# ADDENDUM NO. 1

Perry Township Schools Phase 2:  
Perry Meridian High School Central Plant and Southport High School Electrical Infrastructure  
SPHS: 971 E. Banta Road  
Indianapolis, IN 46227  
PMHS:401 W. Meridian School Rd.  
Indianapolis, IN 46217

**ADDENDUM NO. ONE**

**PROJECT:** Southport High School – Electrical Improvement Package

**ELECTRICAL ENLARGED PLANS**

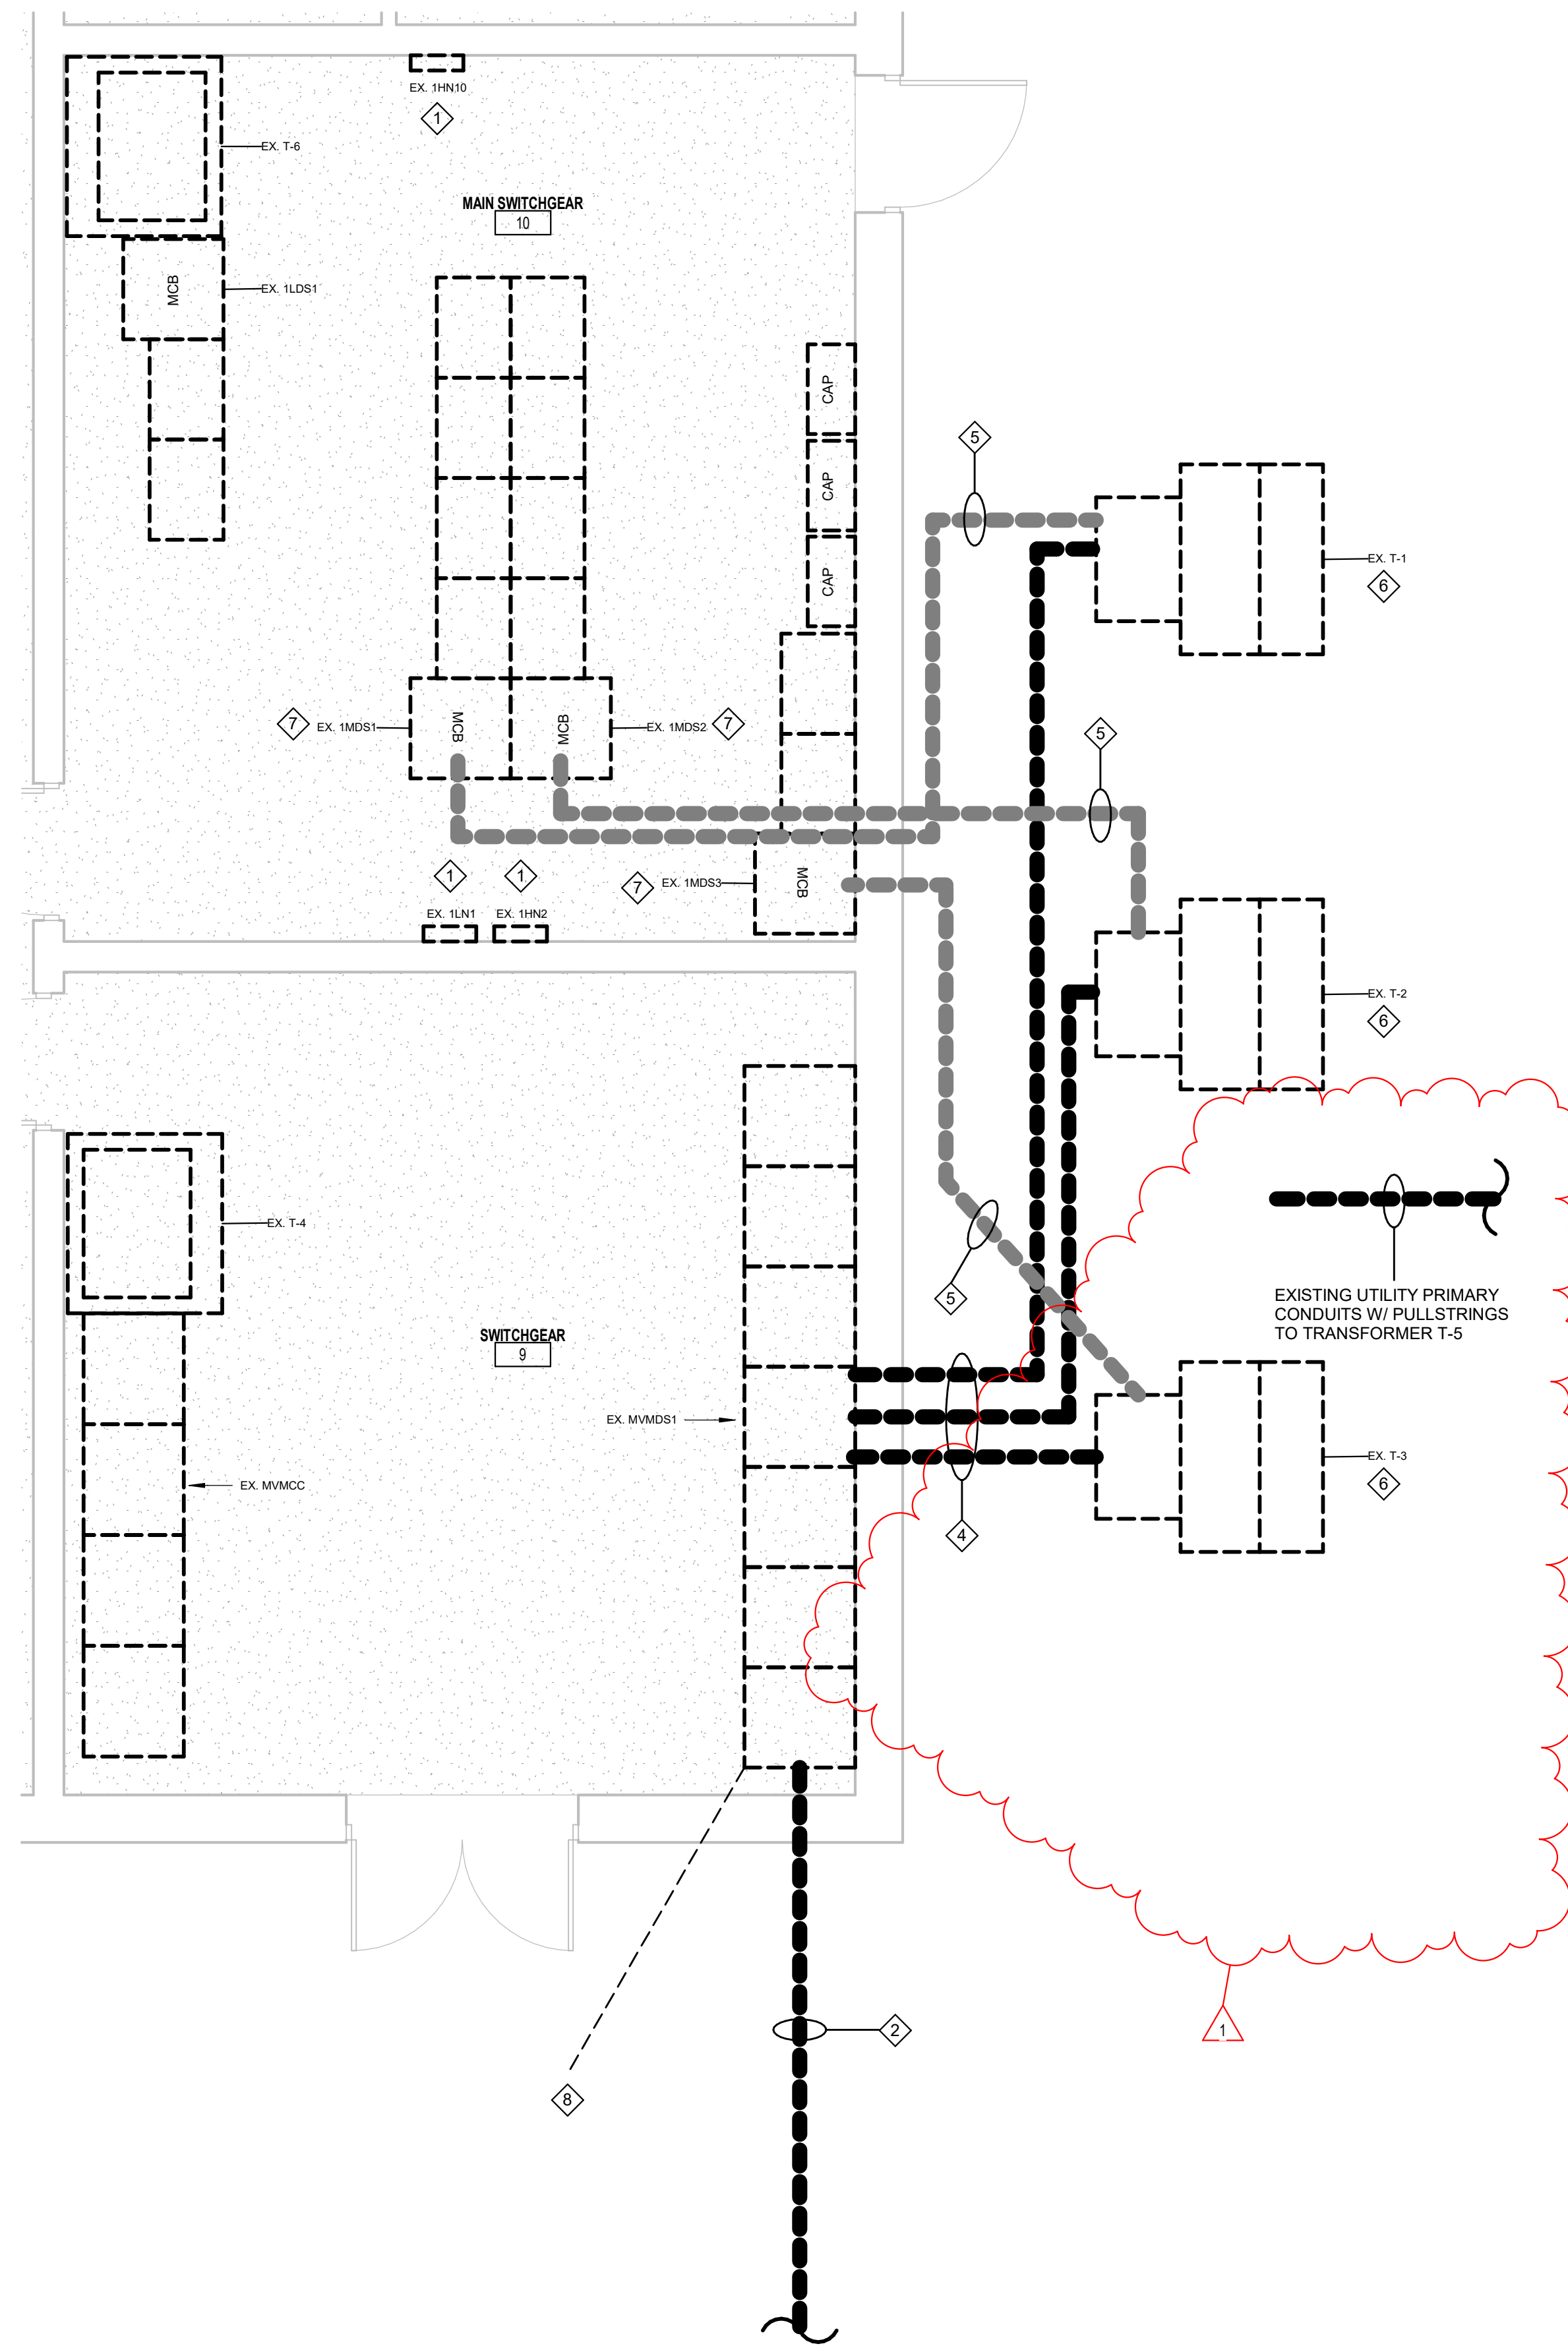
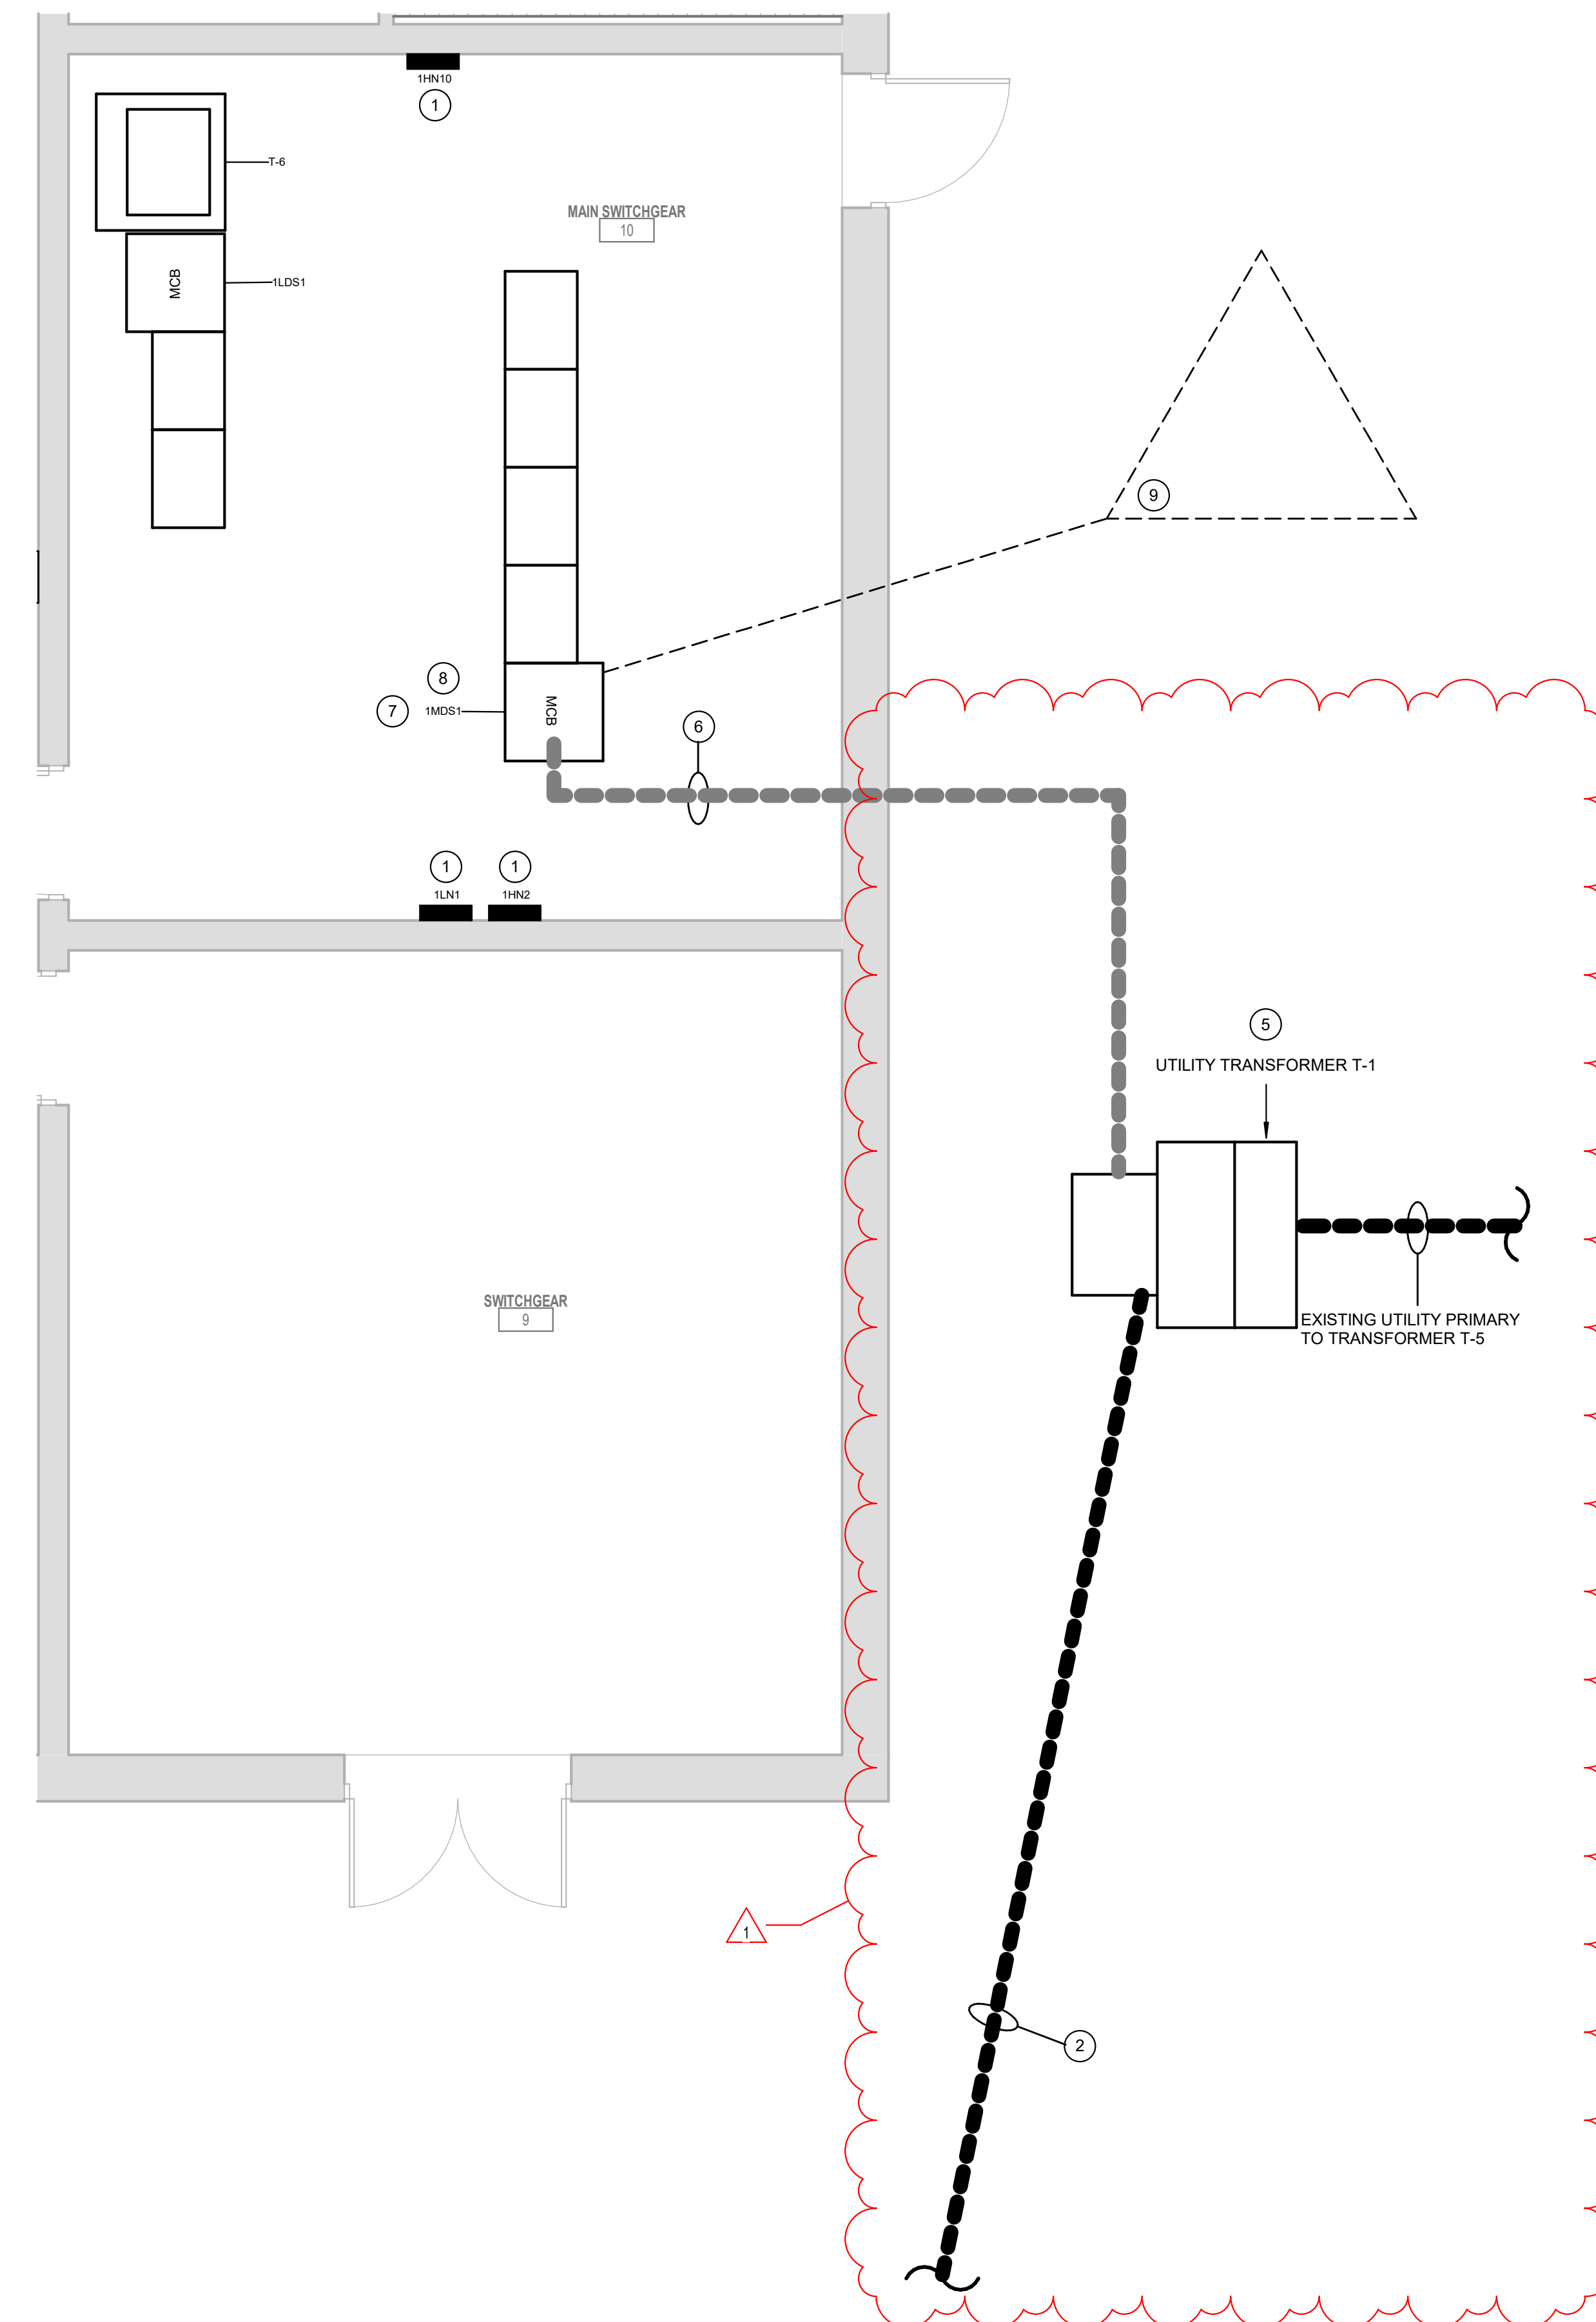
Change: Updated utility primary and transformer installation design per coordination with AES Indiana.

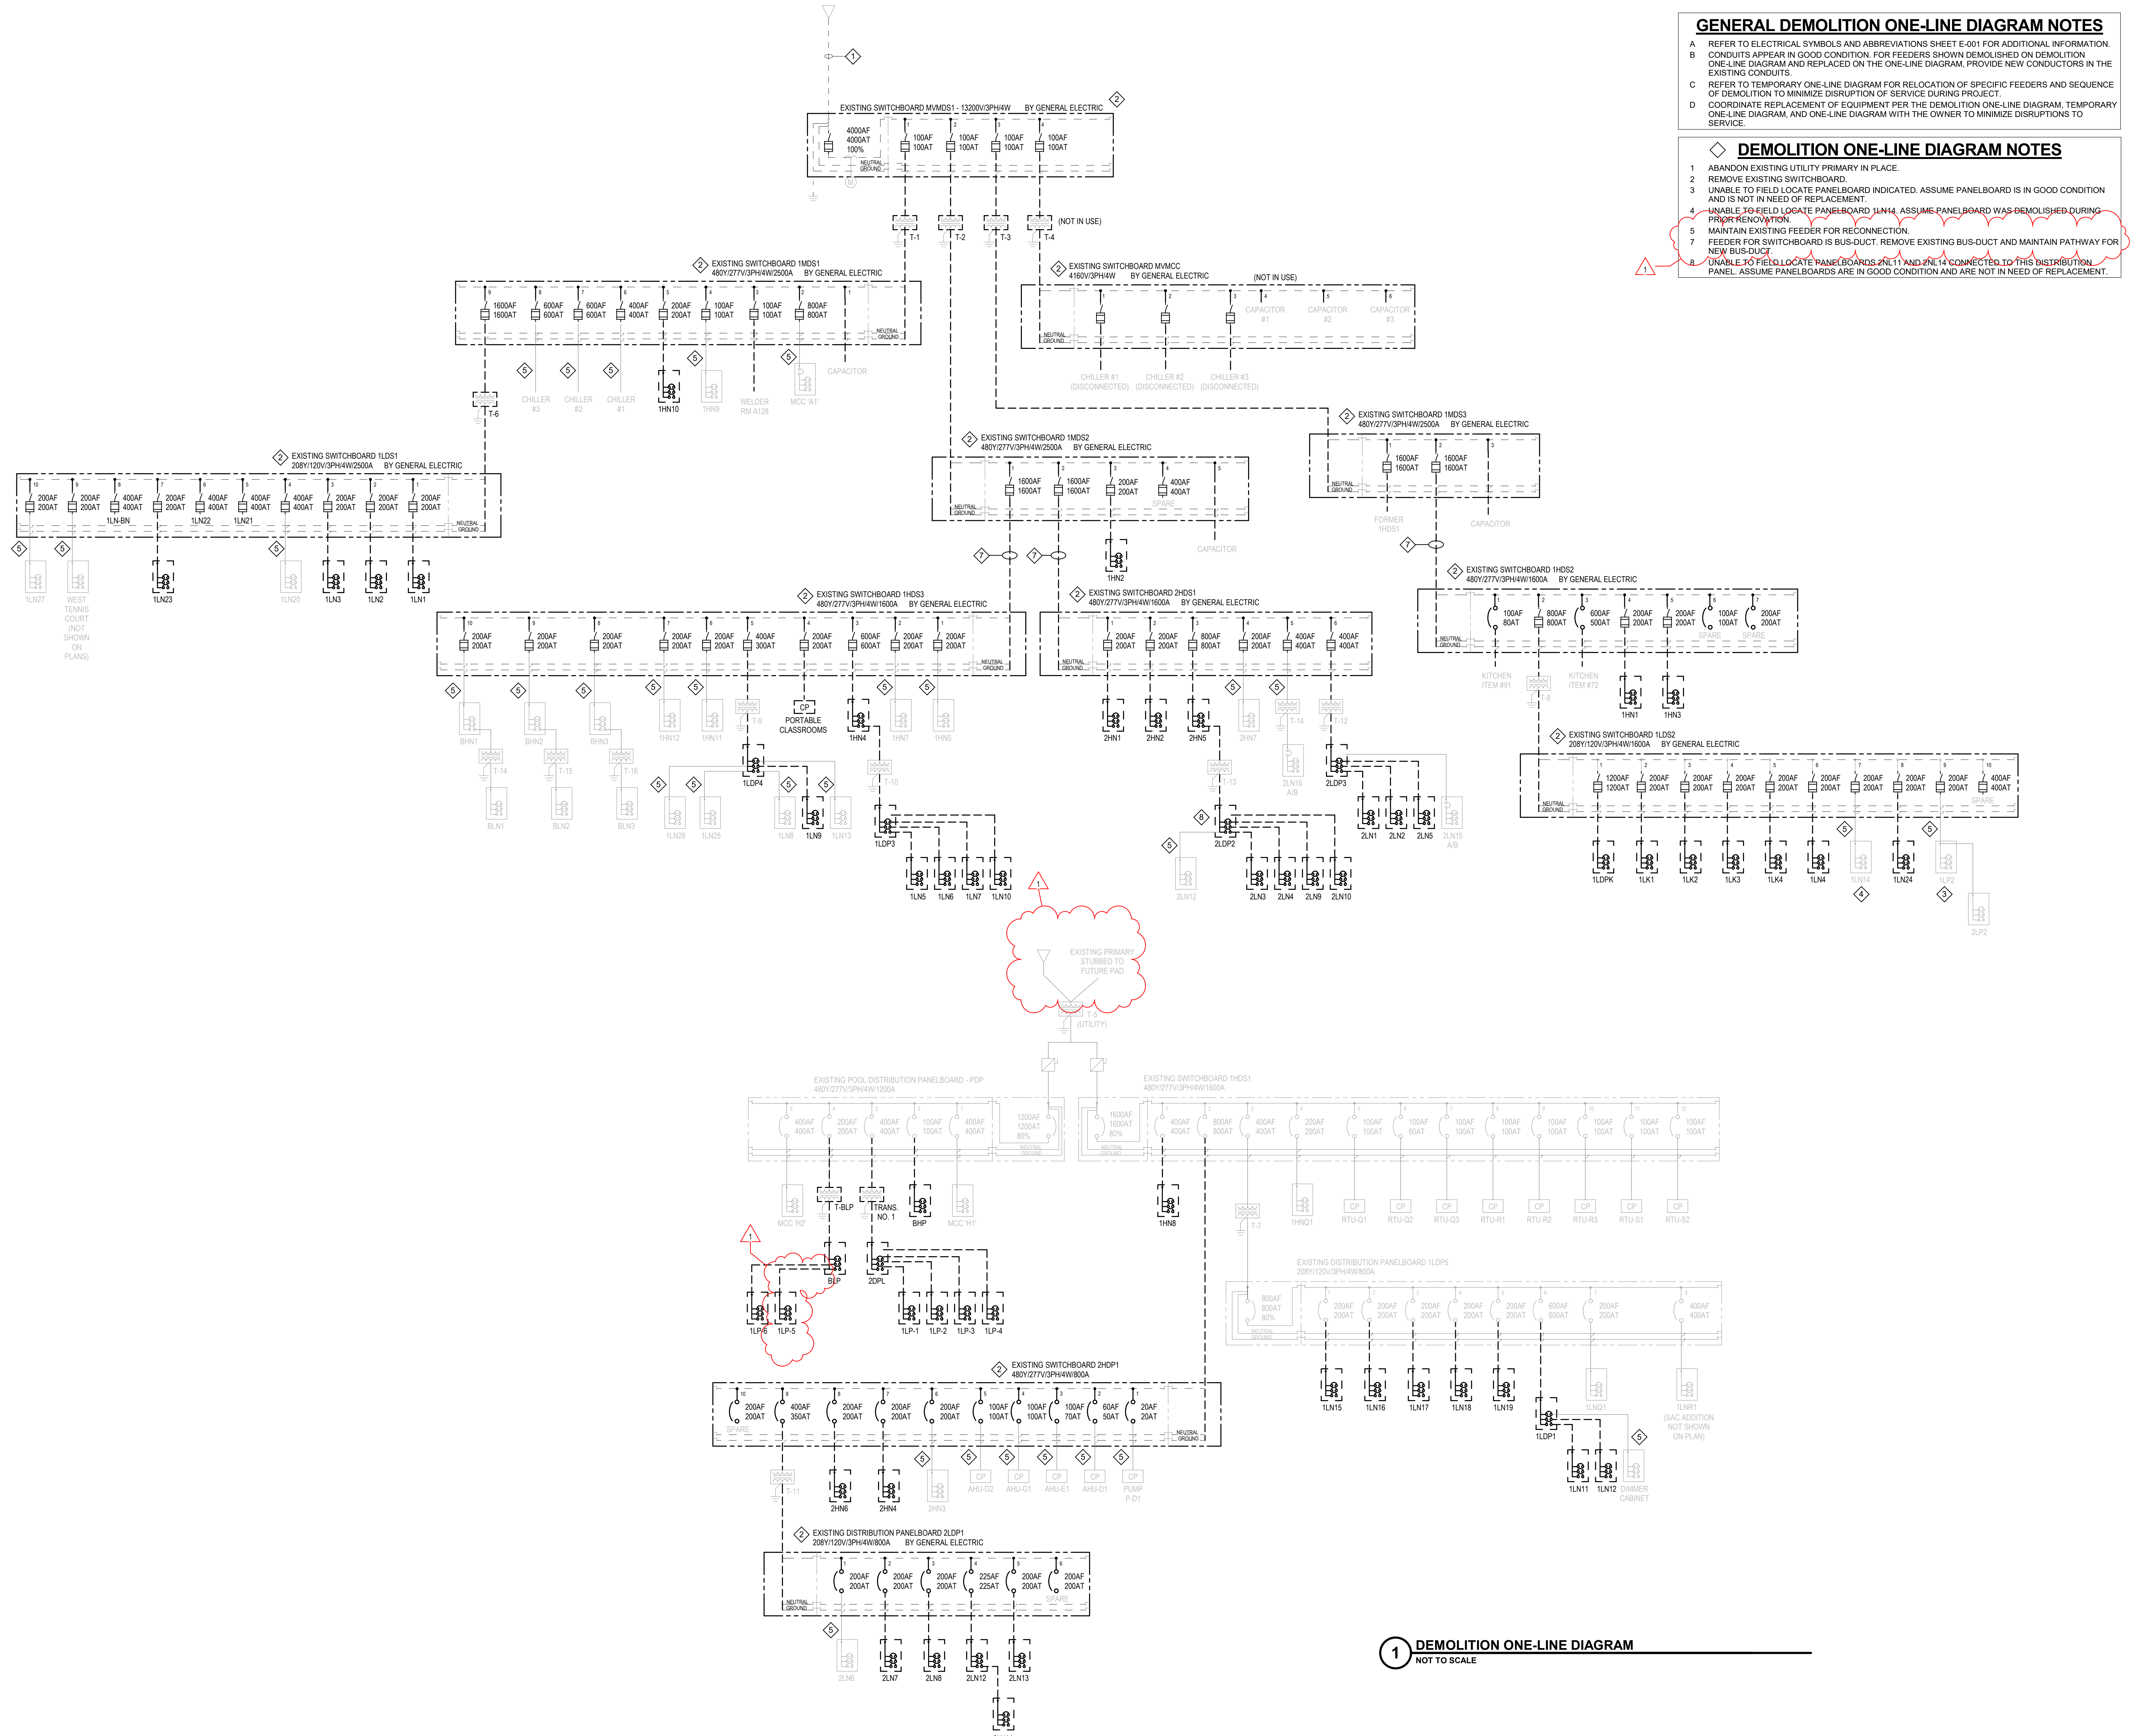
Change: Added schedule for panelboard 1LP-5.
